Product Change Notification

Change Notification #: 107363 - 00

**Change Title: Intel® PRO/Wireless 3945ABG Network Connection
WB Skus: WM3945AGM1WB, M2WB, RWWB,
JPWB (MM#s 878722, 878721, 878749, 878738),
PCN 107363-00, Label, OUI Replenishment, Change
MOW1 Regulatory Markings**

Date of Publication: March 06, 2007

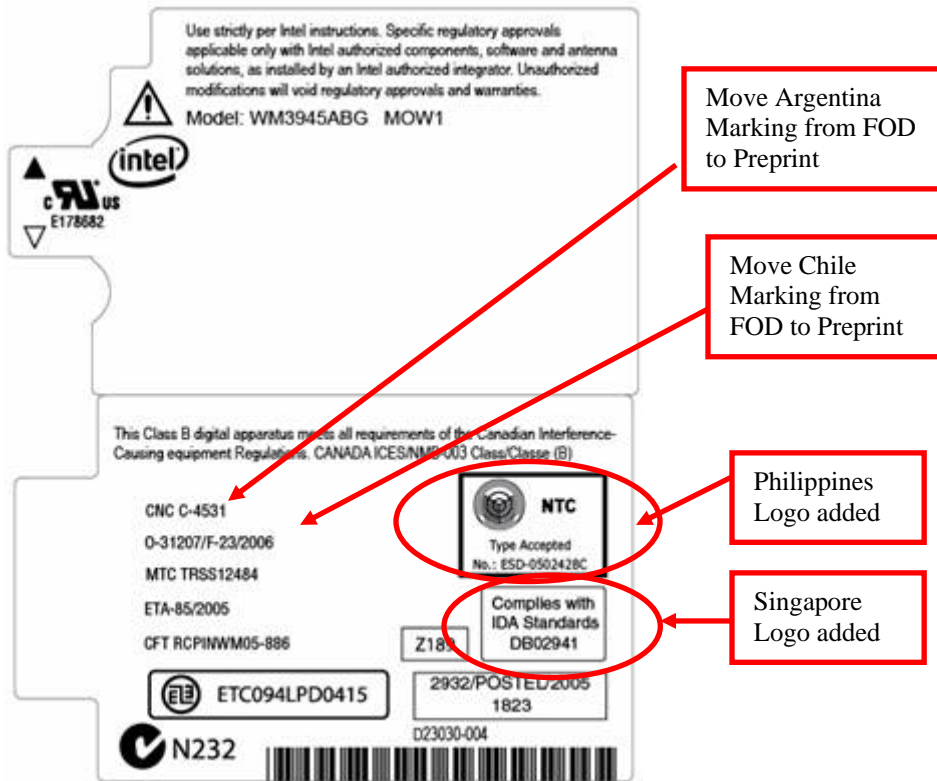
1. Intel has depleted the available 3945ABG MAC addresses in the current OUI block. Allocation of MAC addresses in OUI 00-19-D2 will be exhausted by the end of WW14 (4/6/07). The change is required to continue to provide 3945ABG supply to Intel's customers. All Intel® PRO/Wireless 3945ABG Network Connection skus will be updated with the new OUI numbers.

Pre-Conversion: 00-19-D2

Post-Conversion: 00-1B-77

2. Regulatory marking changes on the M1WB product label
 - Add Regulatory Markings for Philippines and Singapore
 - Move the Chile and Argentina regulatory markings from FOD print to Pre-print label.

1. New MAC addresses with a change in the first 6 characters.
Pre-Conversion: 00-19-D2
Post-Conversion: 00-1B-77
2. Regulatory marking changes for M1WB product label
New M1WB
